RIDGWAY PLANNING COMMISSION

REGULAR MEETING AGENDA

Tuesday, November 30, 2021

To: Town of Ridgway Planning Commission
Cc: Preston Neill, *Ridgway Town Manager*
From: TJ Dlubac, AICP, *Community Planning Strategies, Contracted Town Planner*
Date: October 21, 2021
Subject: McIsaac Subdivision Planned Unit Development Preliminary Plan and Plat for October 26th PC Meeting

ROOF PLAN

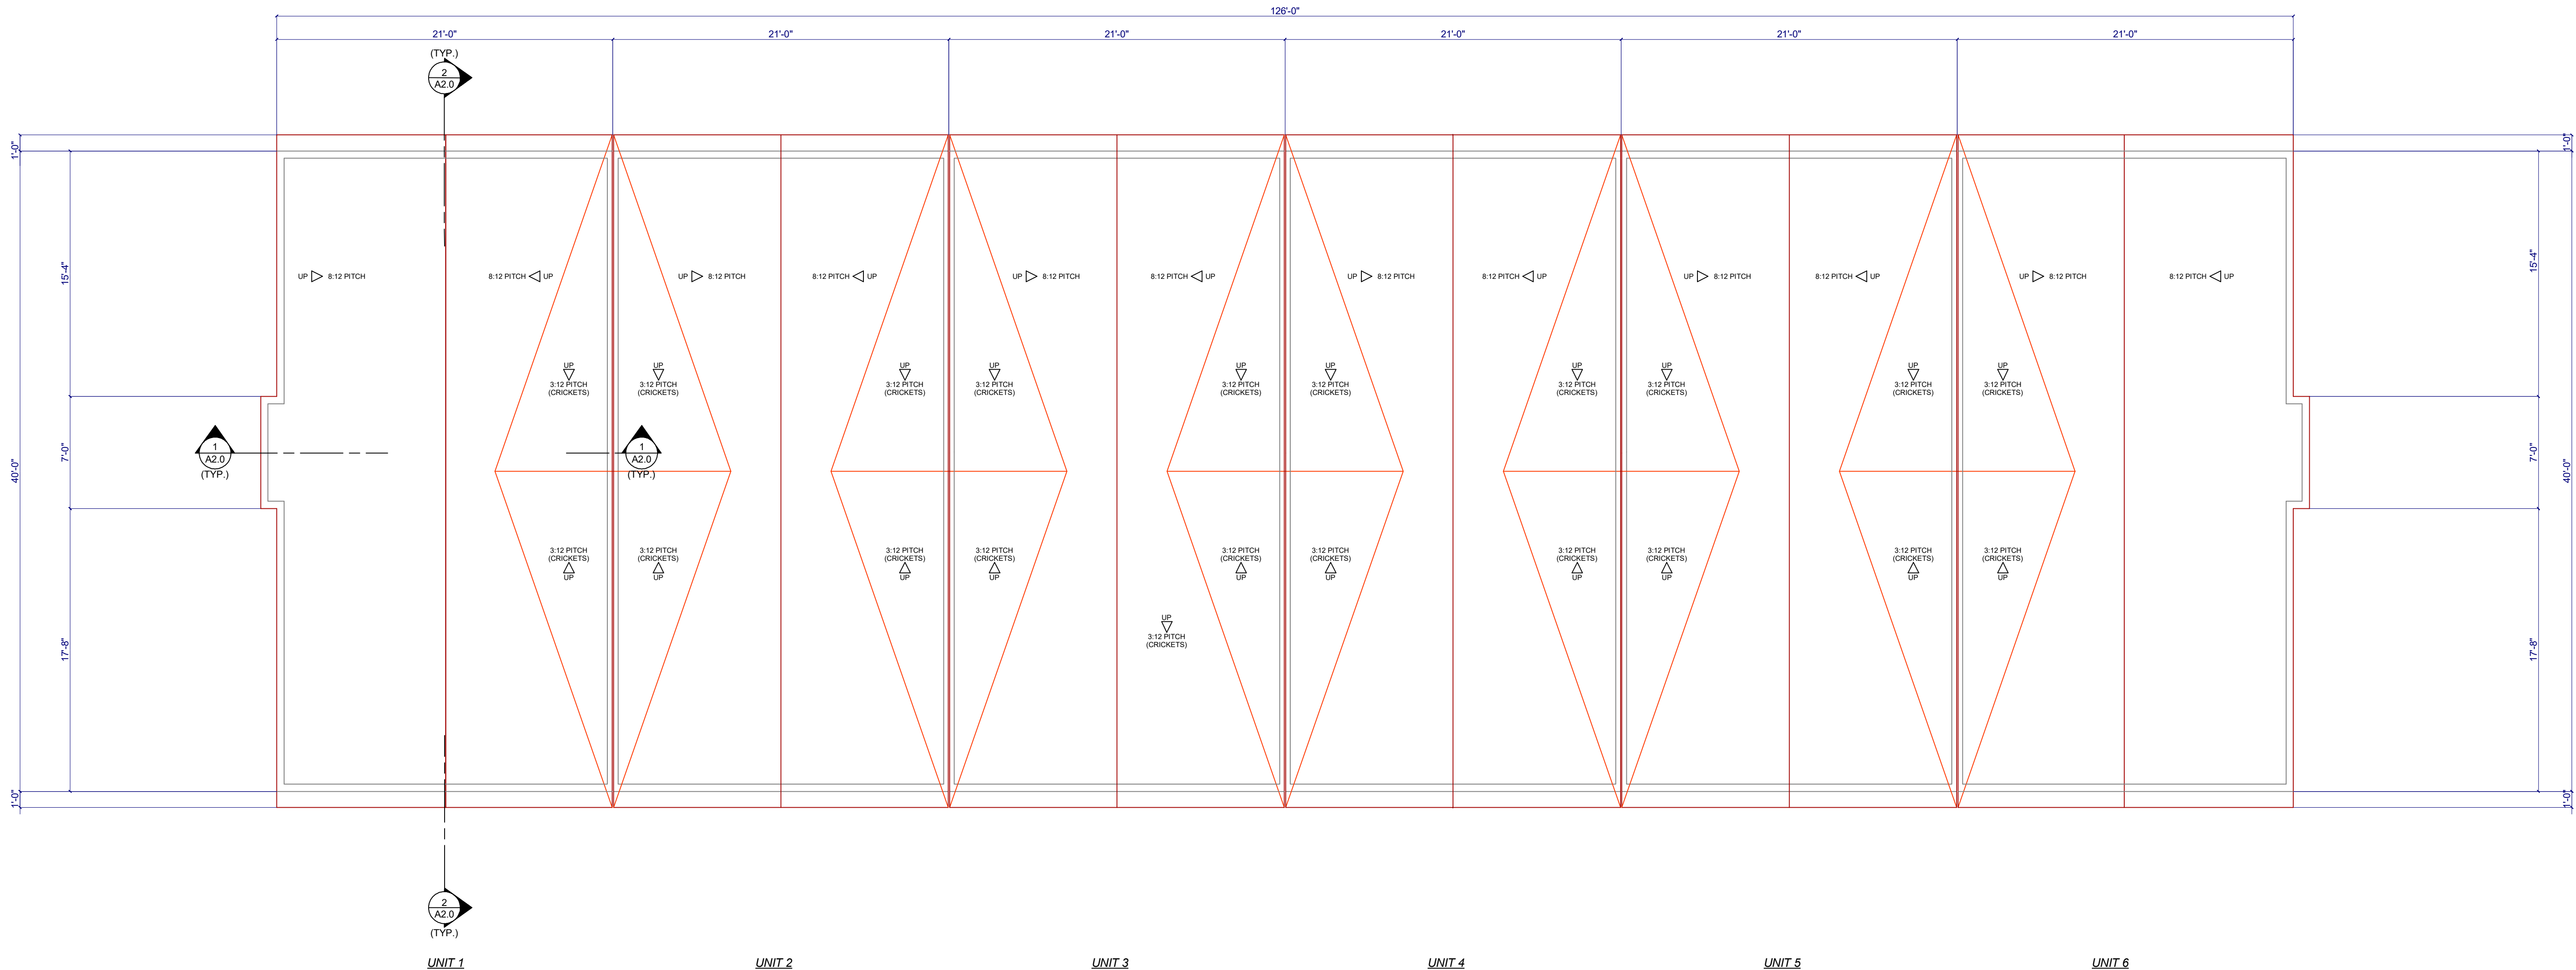
26. July 1 Comment: The roof plan (Sheet A1.0) indicates there are roof overhangs on all sides of the building. However, those overhangs are not indicated, depicted, nor dimensioned on the elevations provided (Sheet A0.0 and A0.1). Please update plan sets to be consistent amongst themselves.

26. RE: Roof overhangs. The roofing plan is correct and shows no overhangs on the east and west, and a 12" "pop out" detail on the north and south (front & back). I have added dimensions to A1.0 (Roof Plan) to make this more clear.

PROPOSED
SITE PLAN
C2.0

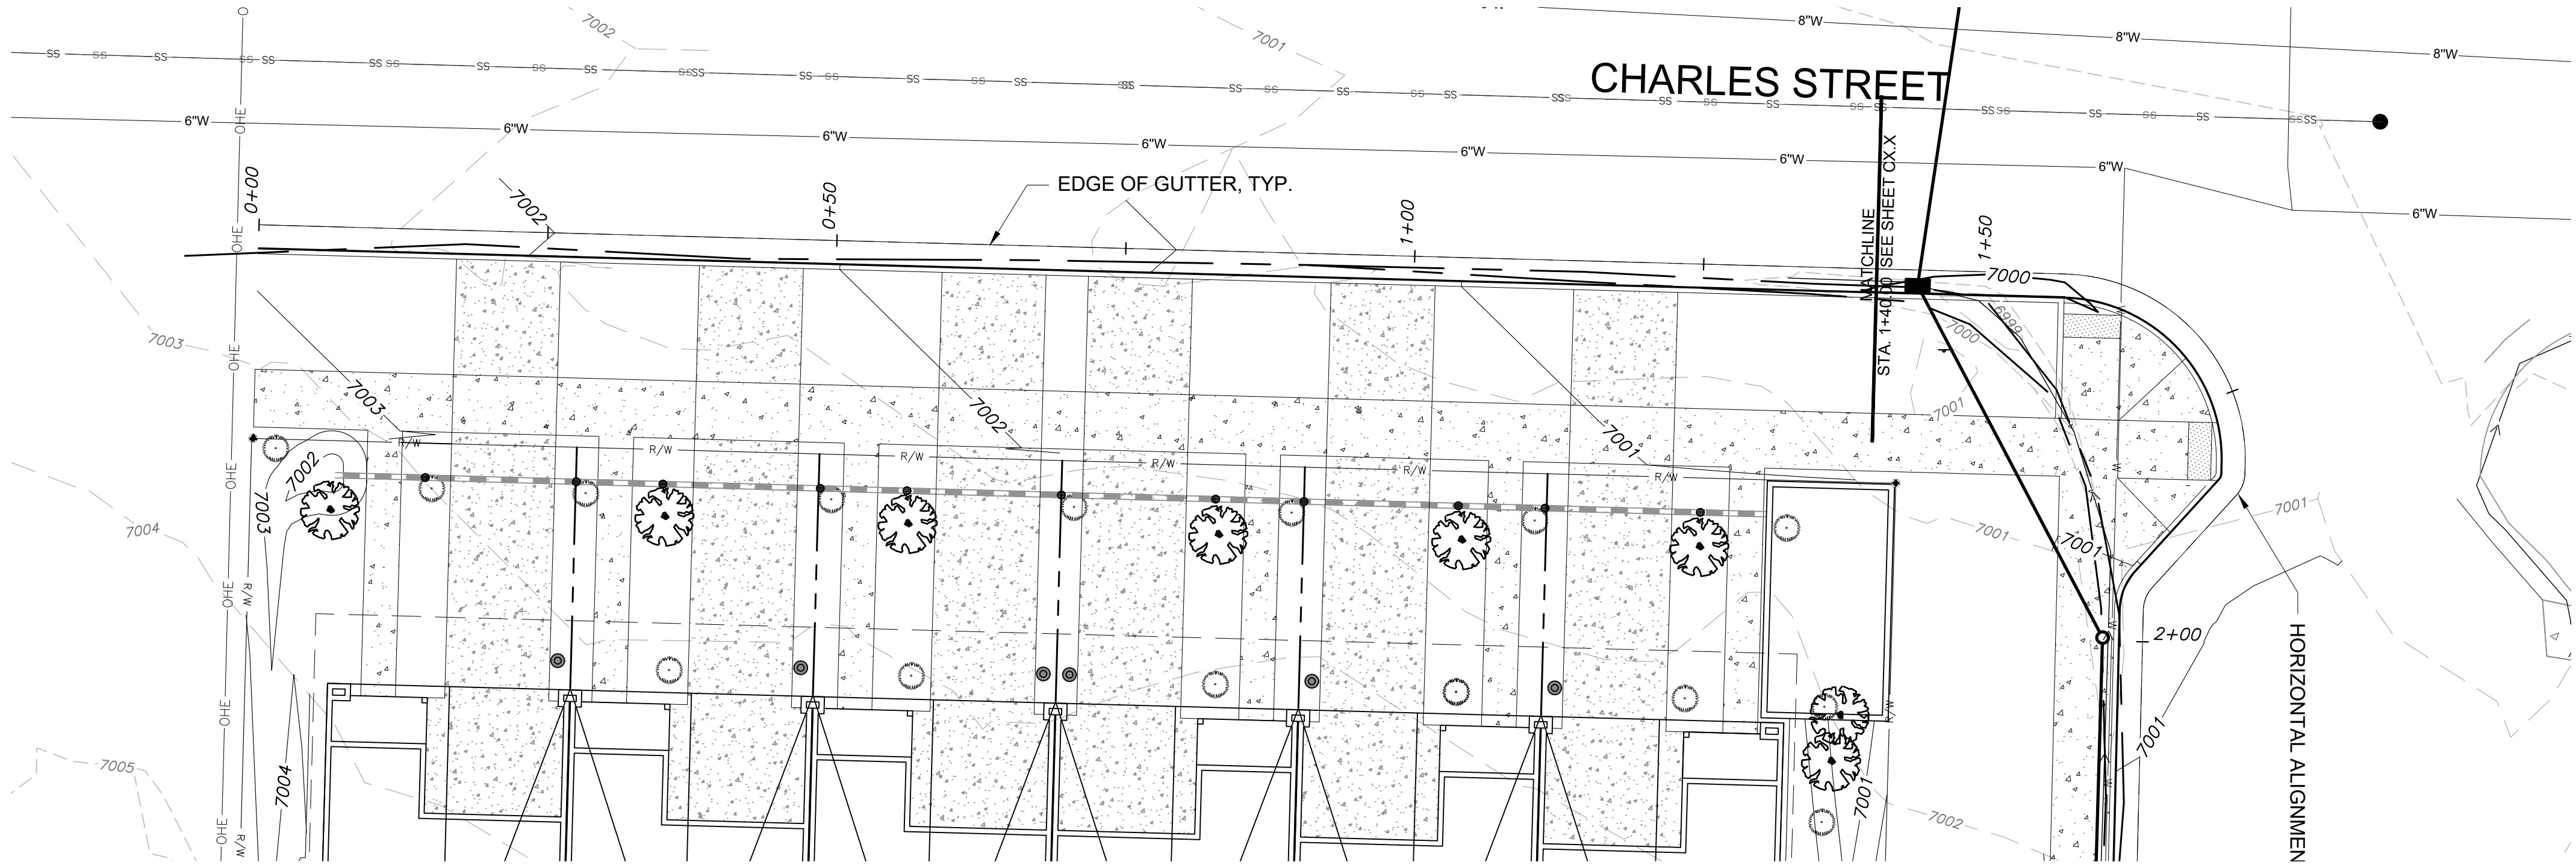
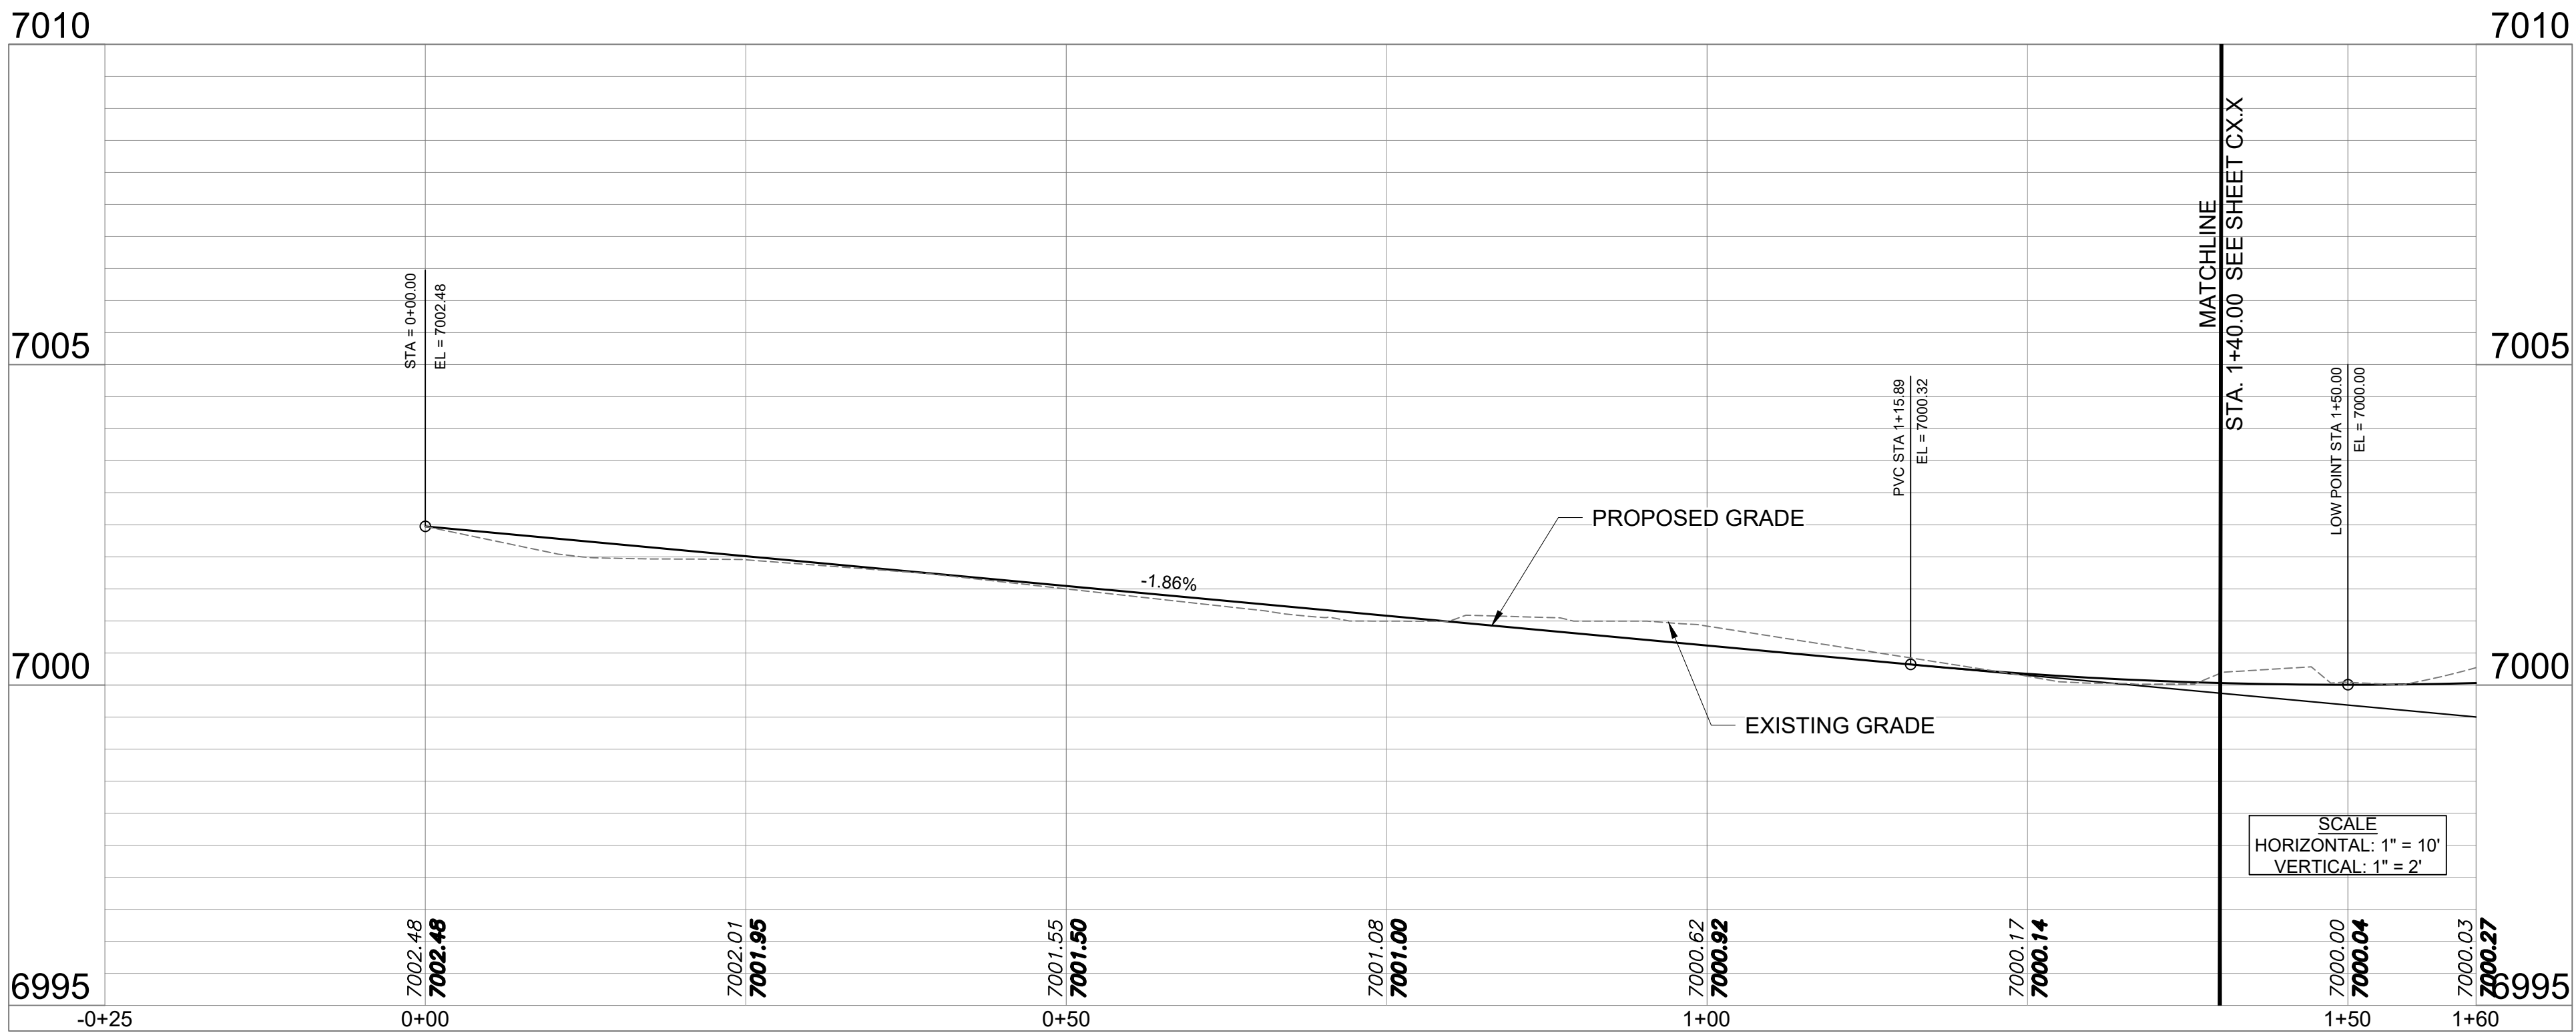
C2.0	Site Plan		Where is snow storage	Found some small areas for snow storage on the right of way. What is the basis for their size? Storm storage needs to be on their property not ROW. The storage areas as currently shown are actually where the sidewalk should go.	Snow storage has been moved out of ROW. Shown on site plan and grading & drainage plan.	
				How do the proposed contours blend with the existing topography		
C3.0	Storm		Space to Create is now running their storm pipe to the east in the E/W alley to Cora and then north to Charles not as shown on this and other sheets. Please update the plan view of the various sheets to reflect the current plan.	Updated		
C4.0, 4.1	Storm		Is the profile shown the lip or gutter, flow line, top back or curb? How does one locate the curb and gutter on the ground?	Not addressed	Station coincides with edge of gutter, please see sheet C4.0 and C4.1	
C4.0, 4.1	Storm		Have storm calcs been provided. What detention is required?	Incomplete info provided. Need to provide design report areas and imperviousness assumptions and consider the impacts for a 25 year and 100 year storm. Based on the Town storm standards it looks like they are going from 2% to 80% imperviousness if we are looking at the parcels being developed which is higher than they indicated	Stormwater report provided.

The bioinfiltration detention unit is shown in the ROW. It needs to be on private property. Did not find any details for the unit. What volume is proposed? What is the nature on the bioinfiltration. How does the runoff get to the unit? Etc. Should provide details in the storm water report.	detention area relocated. Detail added to sheet C6.2	
C4.0, 4.1	Storm		Plans should show inlet elevation and how to locate it on the ground.	Not addressed	Installation by others. Confirmation of invert through as-built.	
C4.0, 4.1			The elevations at the bottom of the profile typical show existing and proposed grades, not the same grades twice.	Addressed		
C4.0, 4.1			Profile drawings are missing slopes in several places. There are no contours on the plan views.	Addressed		
				There should be vertical curves where change in grades exceed 2%. The inlet is at the bottom of the sag should drop about 0.15' into the grate but the gutter should be in a vertical curve so the road can match	Please see vertical curve data on sheet C4.2 in profile.

C2.0	Site Plan	Legend	Legend does not list the landscape items shown on this	Not addressed	Please see legend for corrections.	added trees and shrubs legend						
C2.0	Site Plan		Not seeing existing or proposed contours (Or footprints of the buildings).	Added some contours but not finding that they are labelled on this sheet. It is labelled on the storm sheet	Contours are labelled.	Contour labels added						
C2.0	Site Plan		What is 8:12 slope that looks to be on concrete	Old site plan apparently showed the roof slope. New site plan looks to show building footprint, so comment	Old plan did show roof and associated slope. Now shows building footprint and roof	addressed						
C2.0	Site Plan		Where is snow storage	Found some small areas for snow storage on the right of way. What is the basis for their size? Storm storage needs to be on their property not ROW. The storage areas as currently	Snow storage has been moved out of ROW.	how is snow storage sized. Are all the ansi 33 (solid and dashed) hatch areas to be snow storage. If not please clarify what are. How does the snow from the buildings get to the snow storage.

How do the proposed contours blend with the existing topography	Shown on the site plan and grading and drainage plan	There are places especially behind the C&G where the contours seem to just disappear. Perhaps the existing contours could be in a slightly darker linetype						
C2.0	Site Plan					what are the widths of the driveways? Should they have flared entries. The typical shows 6' flares but the site plans do not. I am scaling 12' between the driveway. If that is correct with 6' flares the curb will be going from flare to flare etc. As noted below the flares should be 12:1 maxslope not necessarily 6'						
C2.0	Site Plan					At the southern end on both the east and west lines of the parcel there is text that is too small to read.						
C2.0	Site Plan					curb gutter and sidewalk should extent to the south property line						
C2.0	Site Plan					is there a detail for where the curb and gutter ends at the south end on Cora. How does it blend with existing barrow ditch. Note that S2C is removing the RCP pipe installed with the RAMP project.
